Proposal for amendment to Regulation No. 46 (Devices for indirect vision)

The modifications to the current text of UN Regulation No. 46 are marked in bold for new characters and strikethrough for deleted characters.

This proposal is updated proposal for VRU-Proxi-02-03 Class VIII field of Vision that mentioned as next action for Japan in 5th 5th VRU-Proxi-IWG.

Figure 11

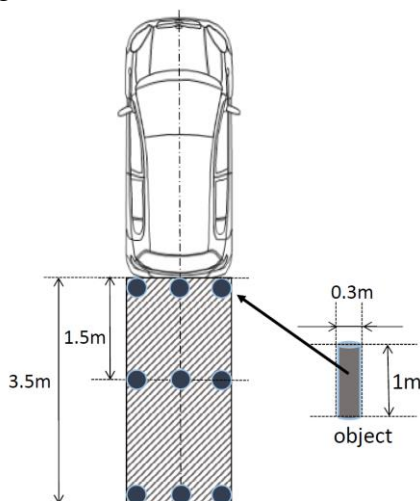
Insert new Figure 11:

" Class VIII field of vision

"15.2.4.8. Class VIII close-proximity rear-view device

15.2.4.8.1. The field of vision shall be bounded by the following planes and shall be such that the driver can see at least part of each cylindrical objects with a height of 1,000 mm and a diameter of 300 mm which is located at 6 positions within the boundaries of the field of vision as defined in Figure.11:

(a) A transverse vertical plane of the outermost point of the rear of the vehicle;

(b) A transverse vertical plane 3,500 mm behind the outermost point of the rear of the vehicle;

(c) Two longitudinal vertical planes parallel to the longitudinal vertical median plane of the outermost point of the side of the vehicle.
